REGULAR MEETING AGENDA

Tuesday, June 13, 2023 6:30 P.M.

Staff Report Comfort Inn & Suites – Hotel 800 S. Hewitt Road Preliminary Site Plan and Special Land Use Review

Preliminary Site Plan Review For Ypsilanti Charter Township, Michigan

FILE NAME : 22060_A.201

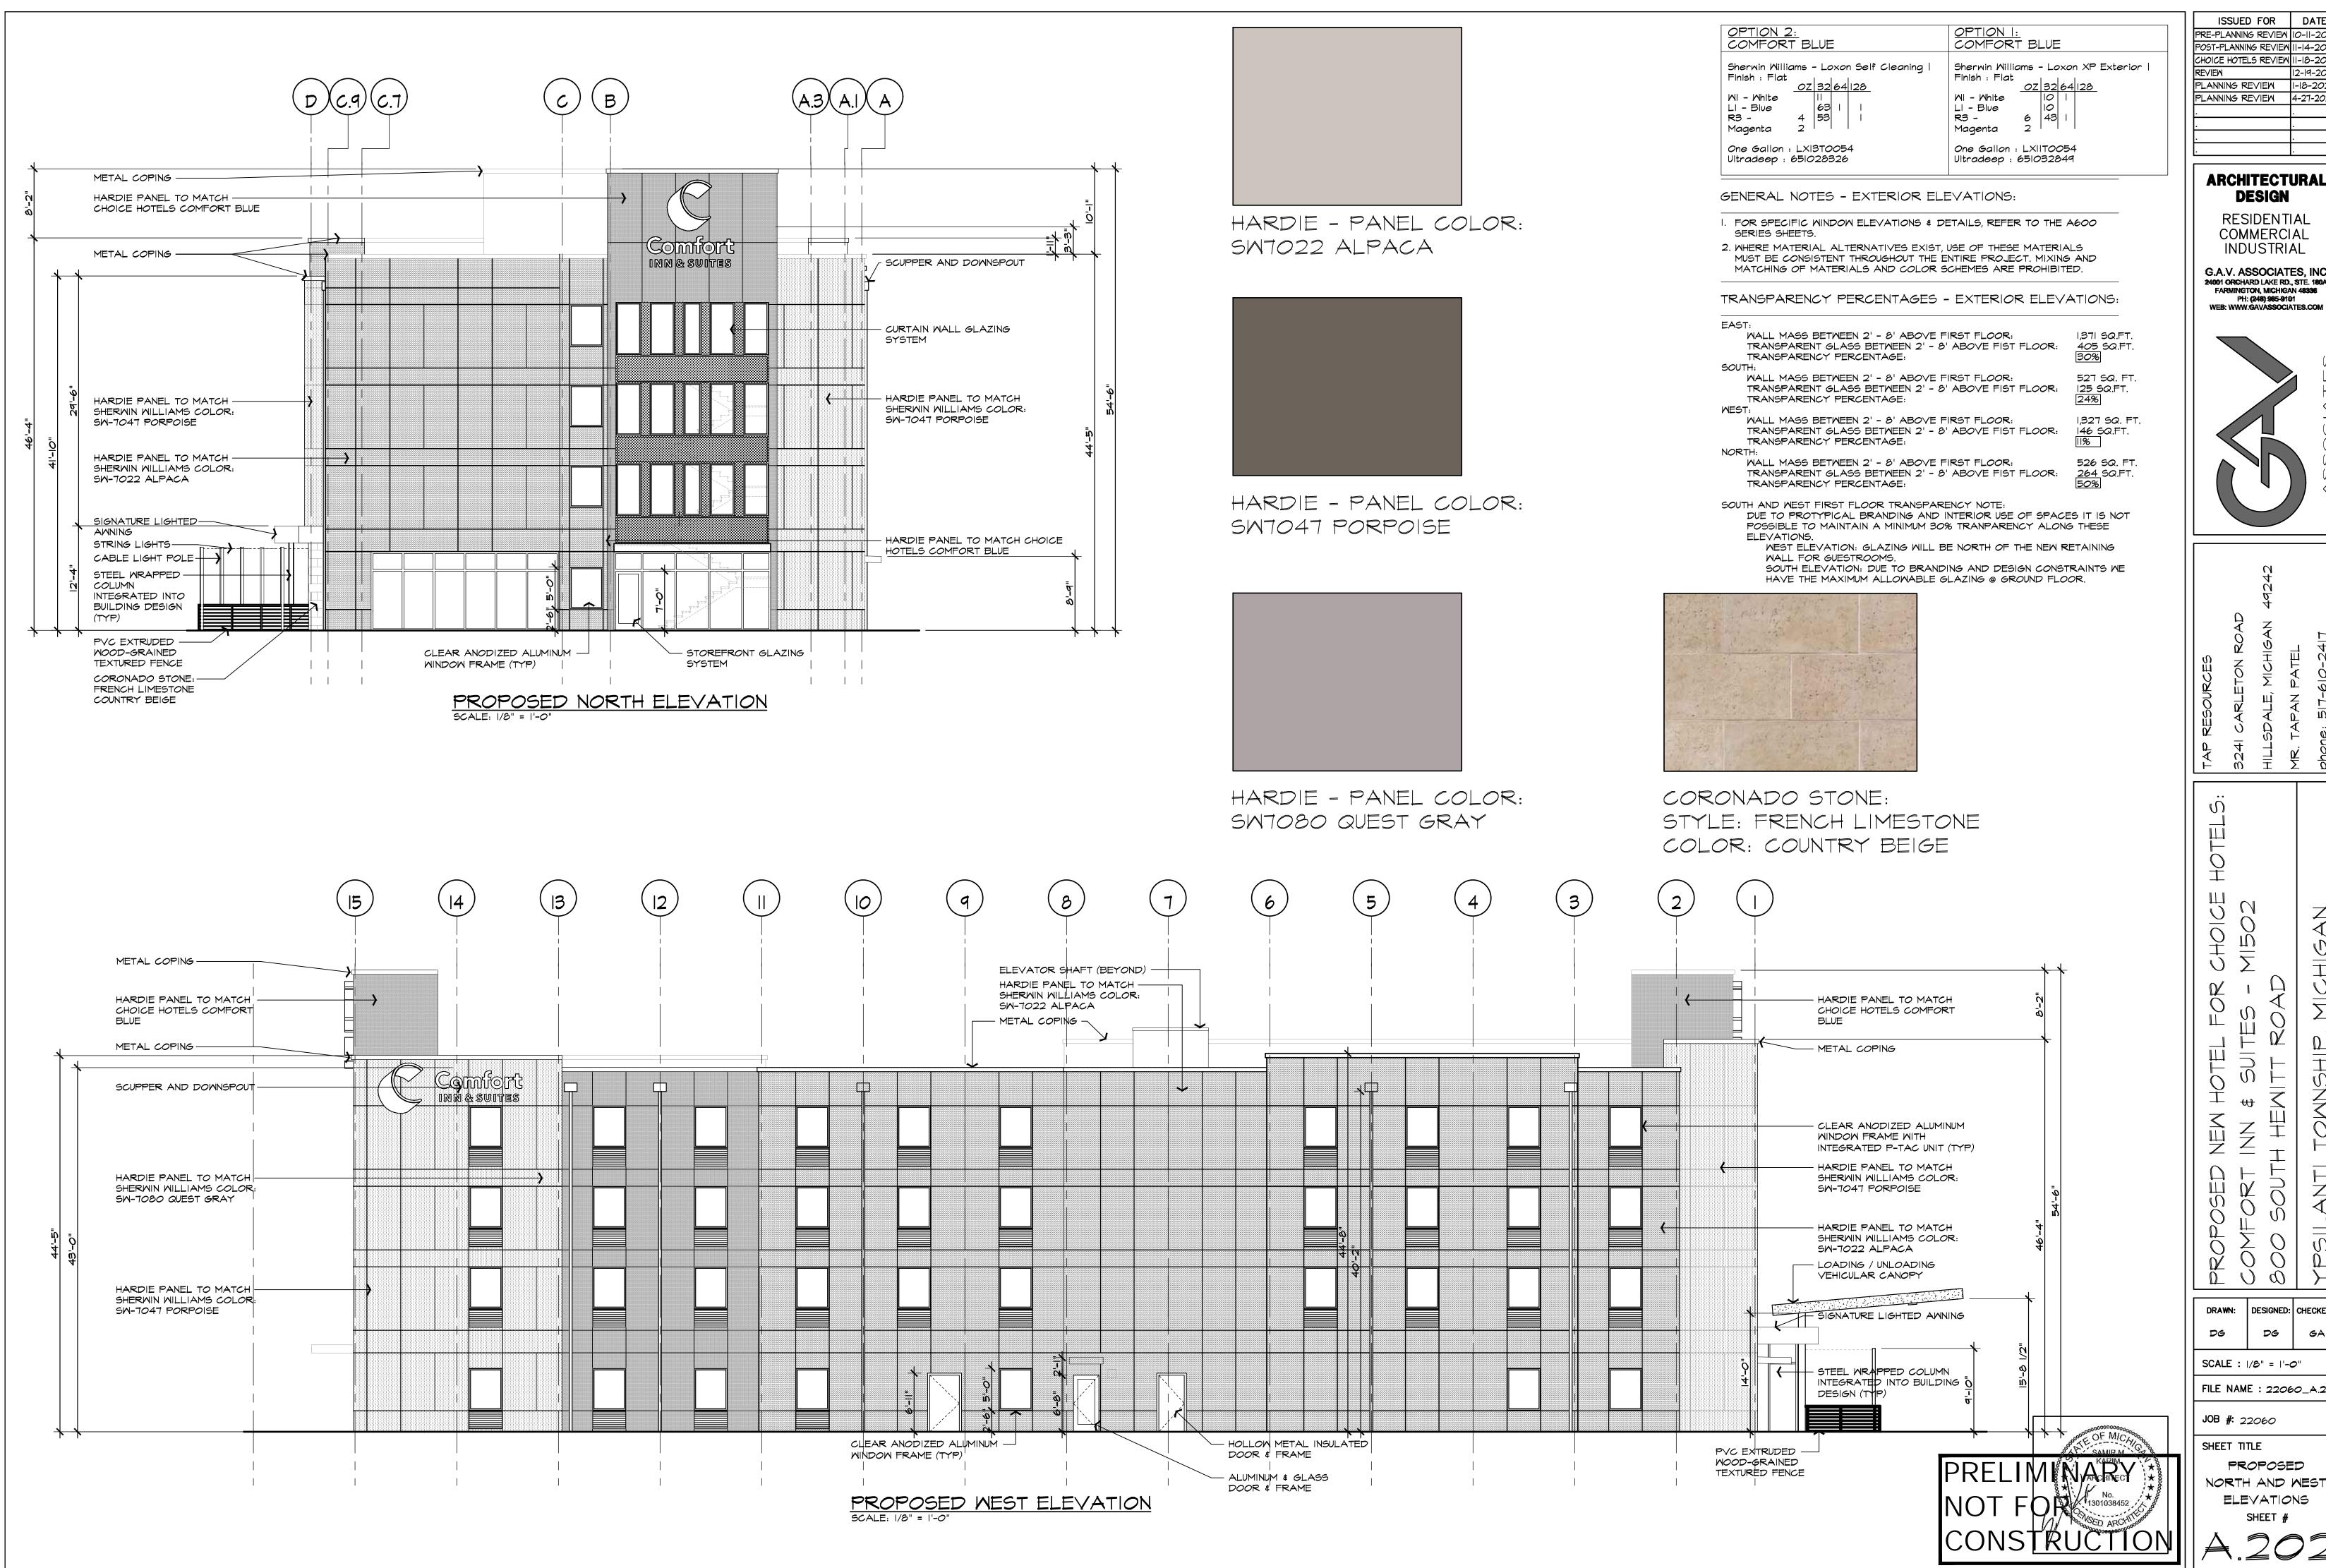
As stated on sheets A.201 and A.202, the north elevation (Michigan Ave) now meets the 50% minimum transparency requirement and the east elevation now meets the required 30% minimum elevation. Due to Choice Hotel design constraints and prototype floor plans, the South and West elevations have the maximum available transparency. The South elevation is at 24% due to the fact it is the entry point for guests to the hotel and the hotel branding depicts a tower in the center of the wall. The main public area has transparency while the stair tower does not as that would detract form the central Comfort Inn & Suites tower in the middle of that elevation. As a result of the management area and back of house design of the hotel, the west elevation has 11% transparency. The actual location of the transparency is at the guestroom areas, that said, guests in those rooms would have views to the outside.
